PRELIMINARY APPROVAL DEVELOPMENT PLAN

Costco Wholesale
Louisville, Kentucky

DRAWING NO.: **C200**

Case No. 15ZONE1008 Binding Elements

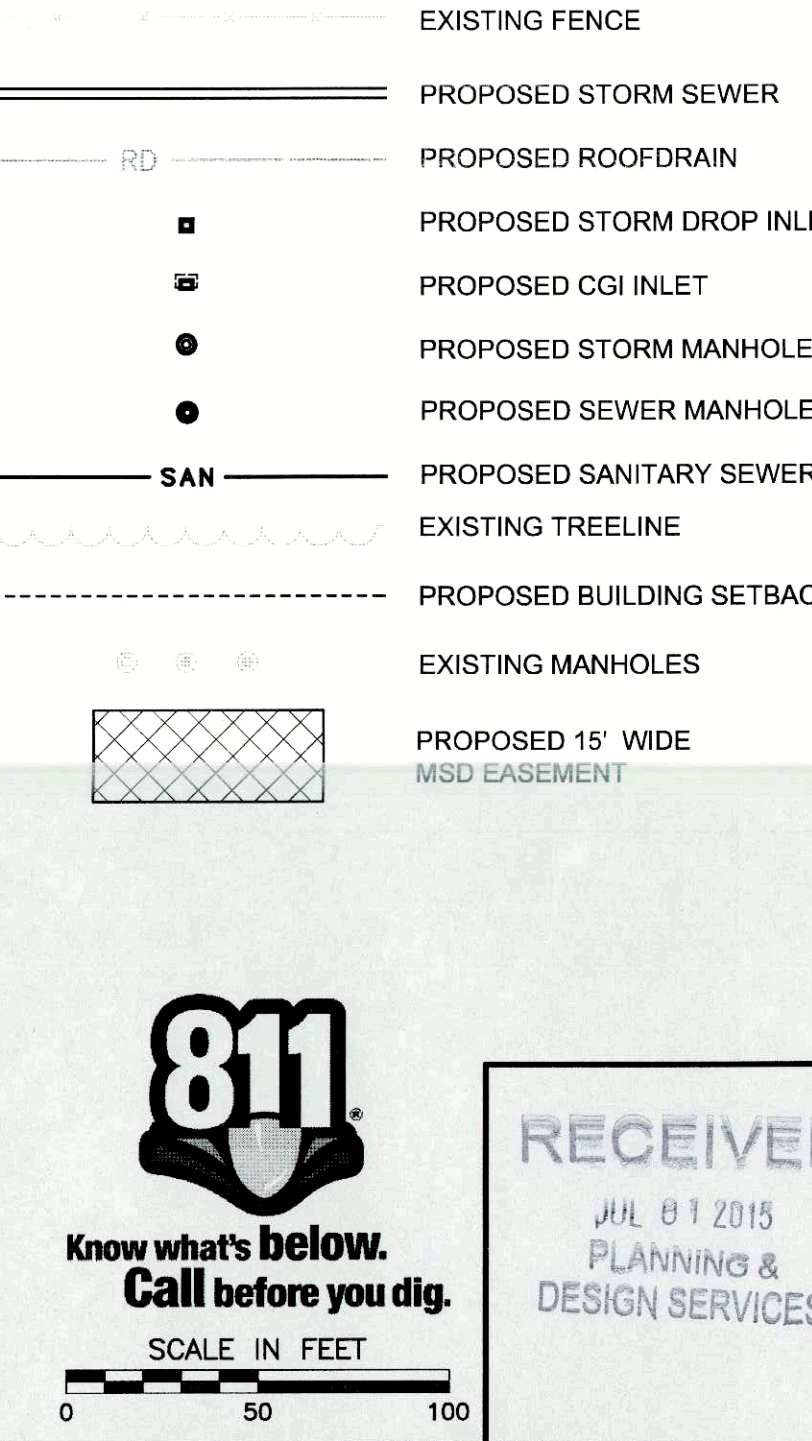
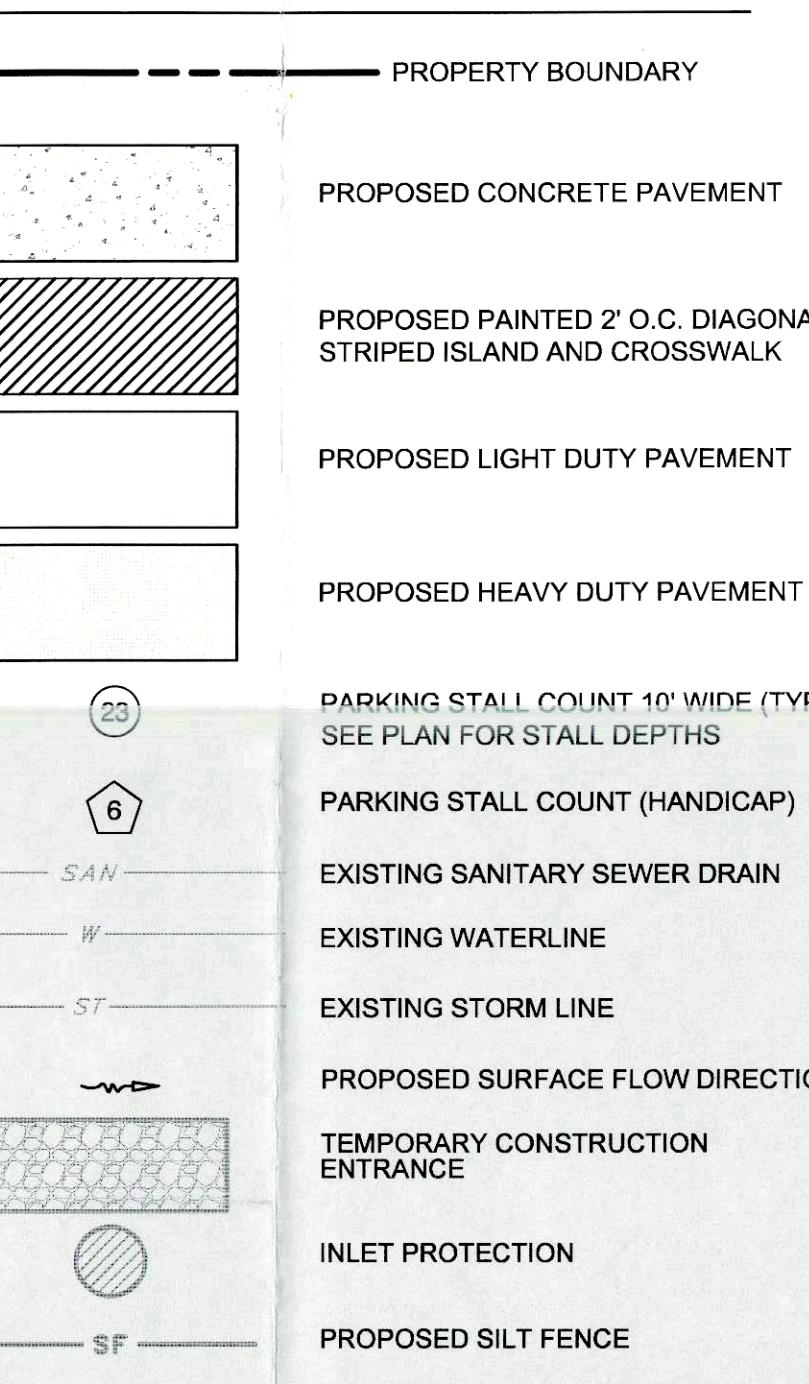
Transportation Planning requested a 3-way stop to protect pedestrian at the crosswalk near the site. Any signal modifications must be approved by KYTC. Costs incurred that relate to modifications shall be the responsibility of the developer. Lane assignments at the signal on site will have a direct relationship to the signal.
